State of New Mexico
 Energy, Minerals and Natural Resources

SUNDRY NOTICES AND REPORTS ON WELLS
 (DO NOT USE THIS FORM FOR PROPOSALS TO DRILL OR TO DEEPEN OR PLUG BACK TO A DIFFERENT RESERVOIR. USE "APPLICATION FOR PERMIT" (FORM C-101) FOR SUCH PROPOSALS.)

EOG Resources, Inc. plans to plug and abandon this well as follows:

Davis #2

Davis #2

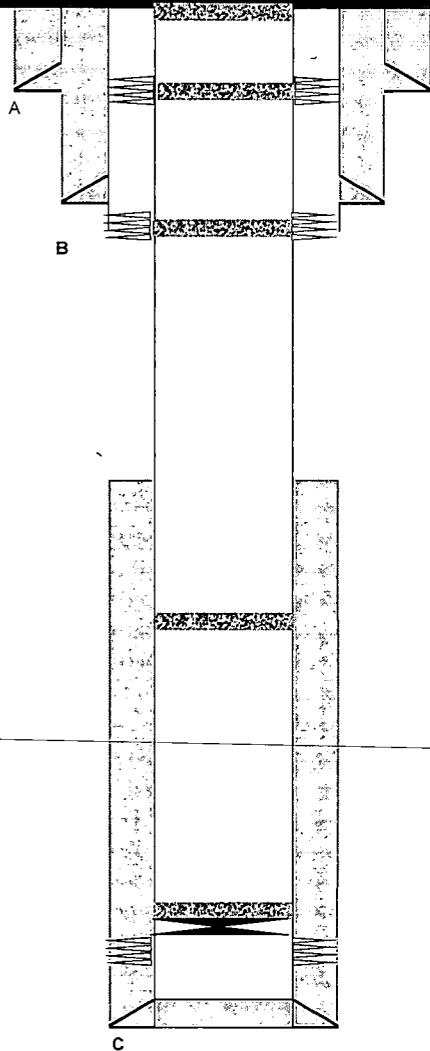
- 1 Set CIBP at 3642 ft with 35 ft of CLS Con top.
- 2 Spot a 25 SX (362 ft) CLS C cement plug 2666 ft - 3028 ft. WOC & Tag Plug. This will plug the Tubb.
- 3 8.625" shoe & Glorieta
- 4 Perforate at 898 ft. Attempt to establish Circulation or spot I/O. Requires 25 SX (362 ft) CLS C cement plug 438 ft - 898 ft. WOC & Tag Plug. This will plug the
- 5 Spot a 10 SX (145 ft) CLS C cement plug 0 ft - 145 ft. WOC & Tag Plug. This will plug the Top.
